## V2500-A1/A5 SERIES PROPULSION SYSTEM NON-MODIFICATION SERVICE BULLETIN

This document transmits the Revision 1 of Non-Modification Service Bulletin V2500-NAC-71-0298

**V2500-NAC-71-0298**  
Transmittal - Page 1 of 1

NON-MODIFICATION SERVICE BULLETIN – NACELLE – FORWARD AND AFT ENGINE MOUNT ASSEMBLIES  
– BOLT IDENTIFICATION

Forward Mount Assembly  
Figure 1 (Sheet 1 of 2)

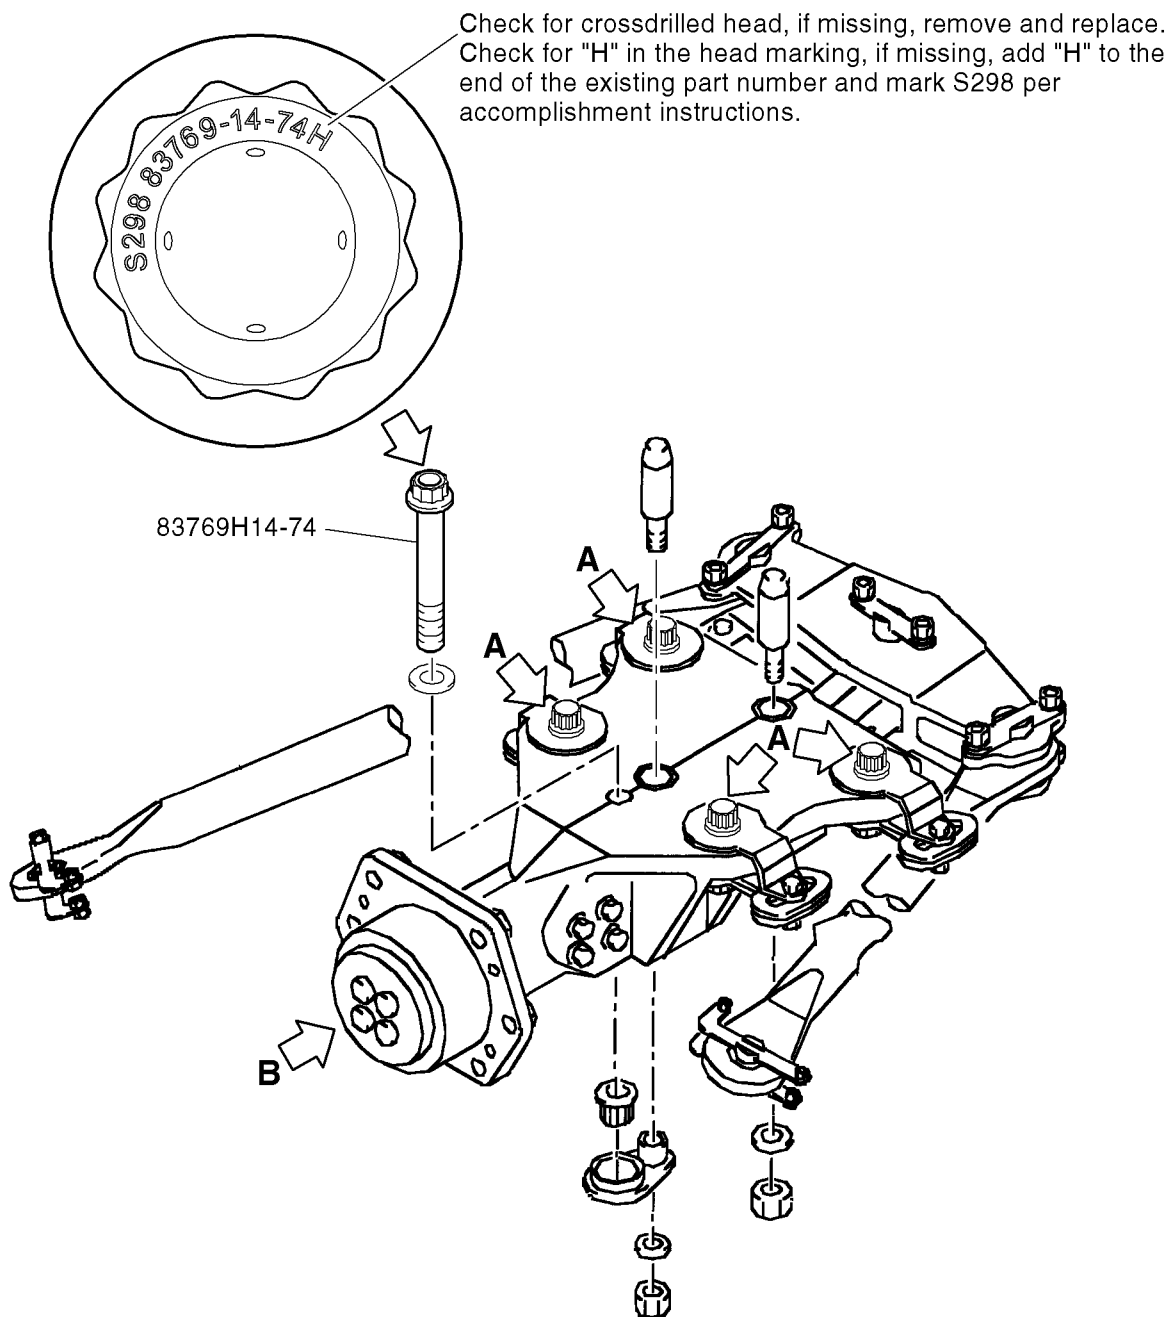
- C. To be completed at next engine shop visit.
- (1) Refer to Table 1 and Figures 1 and 2 to locate affected bolts.
  - (2) Inspect the bolts per CMM 71-21-12-200-001 item 12.

- (3) Use Table 1 to confirm required part number is stamped on bolt head, including any suffix. If the required part number exists on bolt head continue on to next bolt. For bolt 275B0307-7H only, the existing part number may need to be crossed out to ensure proper bolt marking. See Table 1.

- (4) If part number is incomplete, verify that the head is crossdrilled, if missing, remove and replace the bolt. If the head is crossdrilled, remove bolt and electroetch the required part number on the bolt head at a depth of 0.010 in max. Refer to the IAE V2500 Standard Practices/Processes Manual, Chapter 70-09-00.

Forward Mont Assembly  
Figure 1 (Sheet 2 of 2)

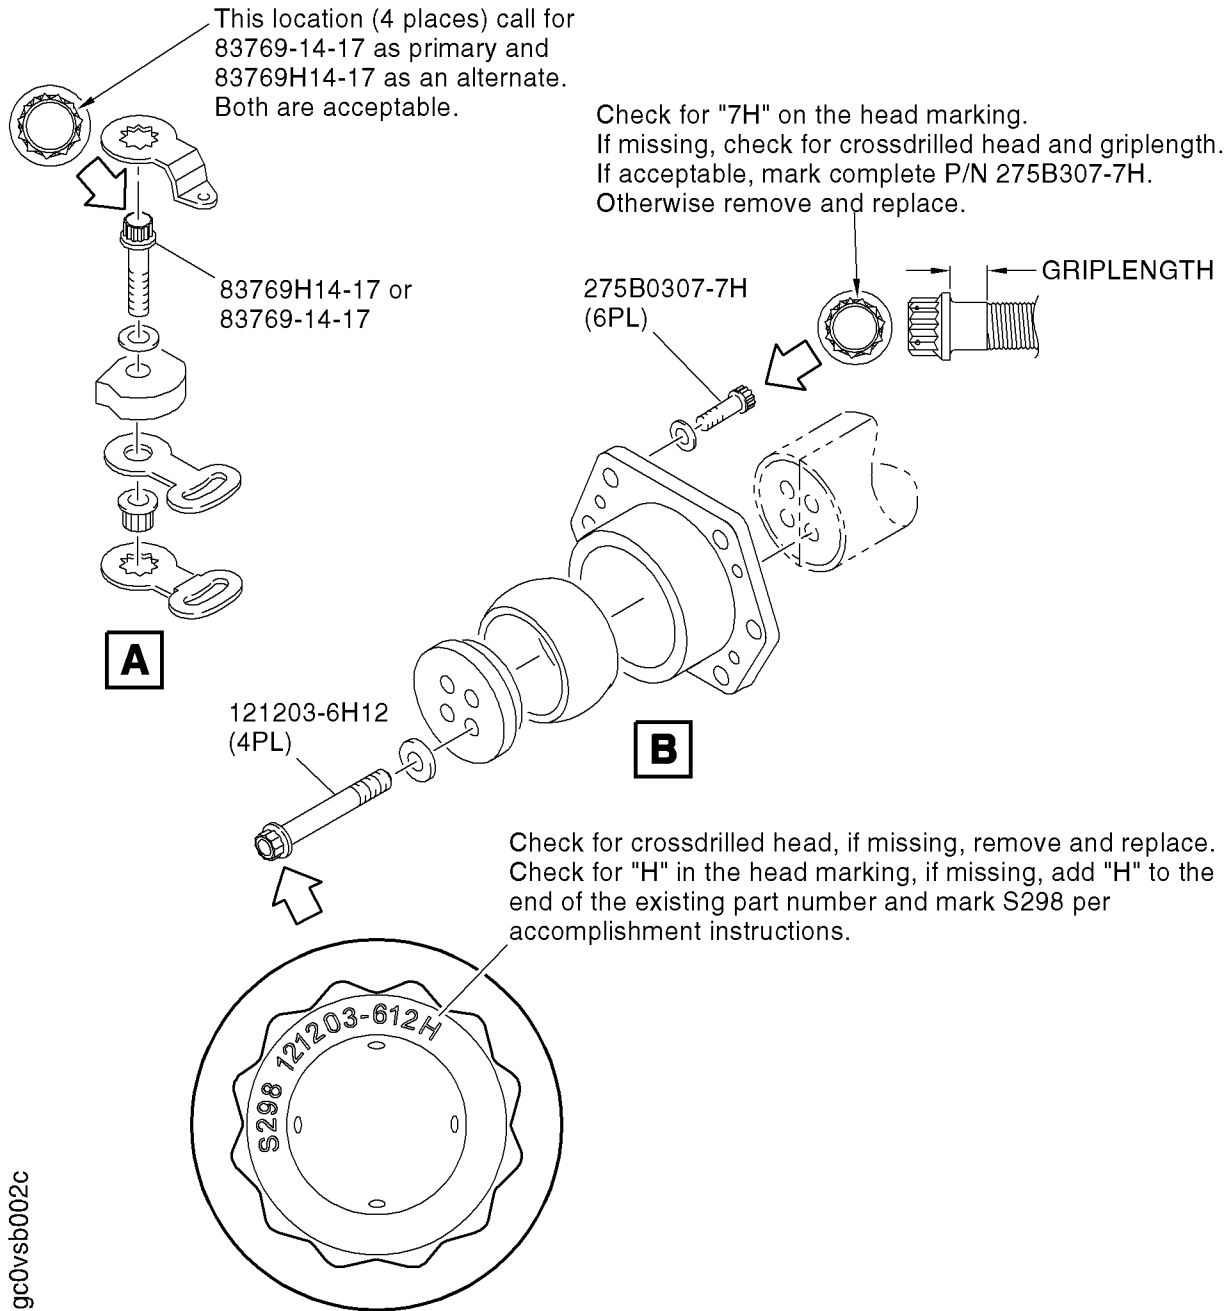
If the '7' in the suffix is not stamped on the bolt head, remove bolt and measure grip length to ensure it is 0.4375 in +/- 0.010 in or 11.1 mm +/- 0.3 mm. Refer to Figure 1 Sheet 2 to measure griplength. If the length does not meet the requirements, replace bolts per AMM 71-21-12-410-064.
